Seat Harness Routing (Swivel)
 VAH, VHD, VN

FSB 375-011, Seat Harness Routing (Swivel)

(March 2014)

W3088667

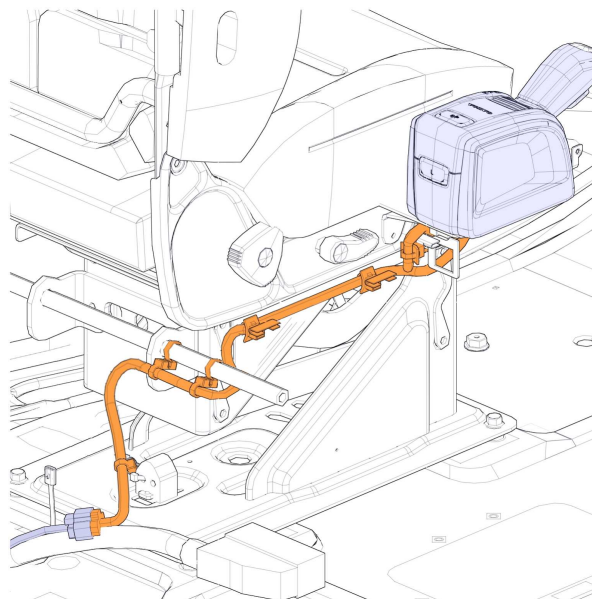
Vehicles equipped with a driver side swivel seat and I shift transmission built prior to November 06, 2013, may experience the seat harness dropping or pulling away from the clipping points. This could lead to the harness rubbing or wires being pulled out of connectors during operation.

To correct the situation a new routing has been implemented to prevent the above failures.

W3076421

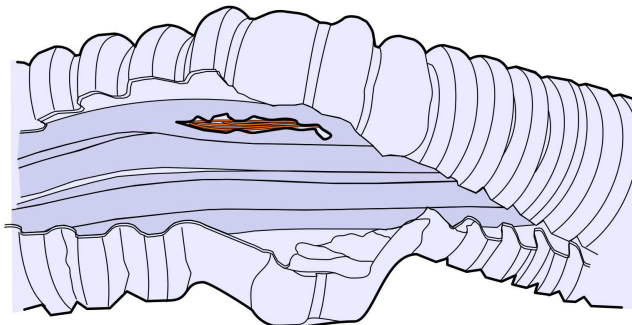
Note: Look for chafed wires. Reuse harness if undamaged. If damaged repair as necessary.

W3088667

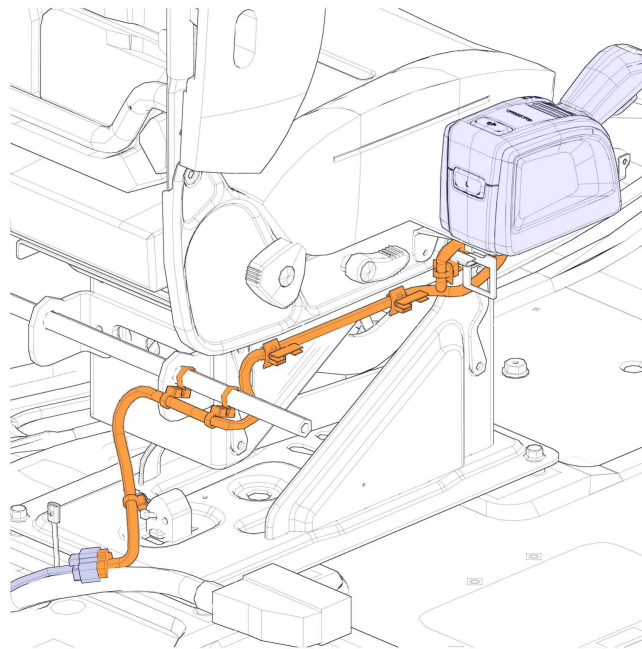
- 5 Loosely install and cable tie along the new path for routing and clipping.

Note: Do not tighten cable ties fully at this time.

Correct Routing
Cable Tie with Horizontal Edge Clip # 21096682, Qty 2

W3076416

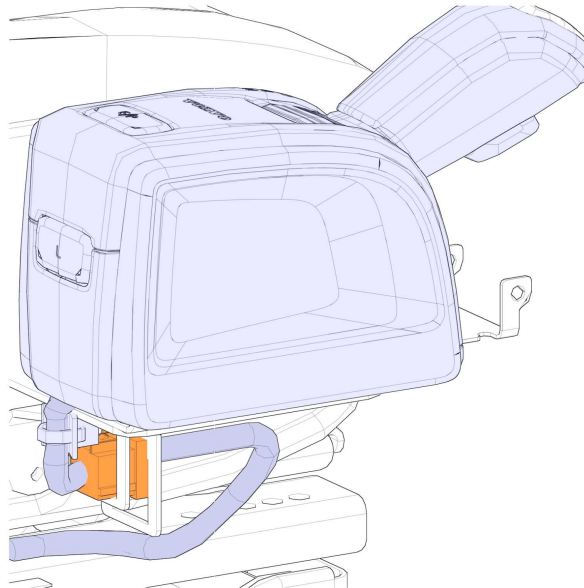
- 6 Connect the wiring harness connector at the shifter.

Note: The strain relief loop going to shifter will have increased in length with new routing and clipping method, to ensure no strain on wiring harness or shifter connector with seat in swivel position.
